ADVISORY BOARD ON RADIATION AND WORKER HEALTH

**A REVIEW OF NIOSH'S PROGRAM EVALUATION REPORT
OCAS-PER-005, "MISINTERPRETED APPLICATION OF THE
EXTERNAL DOSE FACTOR FOR HANFORD DOSE
RECONSTRUCTIONS"**

**Contract No. 200-2009-28555
SCA-TR-PR2013-0013, Revision 1**

January 2013

Figure 1. Current Status of PER-005 Impacted Cases

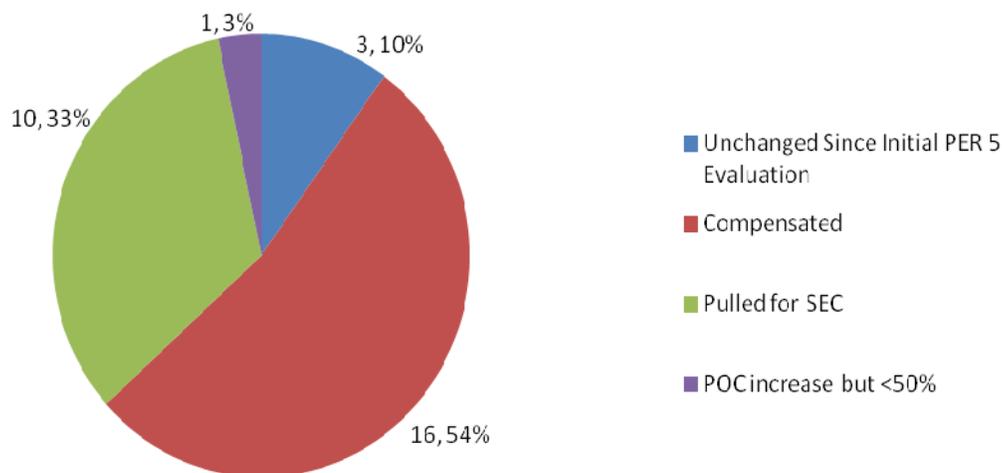
Selection of DRs for SC&A's audit by the Dose Reconstruction Subcommittee will be limited to completed DRs that have been adjudicated by the DOL. Based on the above evaluation, aside from the compensated cases, only 4 of the 30 cases are eligible for audit, and only 1 of those cases has (presumably) been updated to remove the bias correction factor. These cases are identified by the NIOSH-assigned random numbers in Appendix B.

Based on this evaluation, as well as the finding from Section 2.0 of this report (i.e., questioning whether the use of the Best-Estimate Tool is the only avenue for introducing the bias correction factor), SC&A believes at this time it is inappropriate to perform case audits. Pending the outcome of the resolution to SC&A's finding, a decision can be made regarding the selection of cases to audit under the PER-005 review.
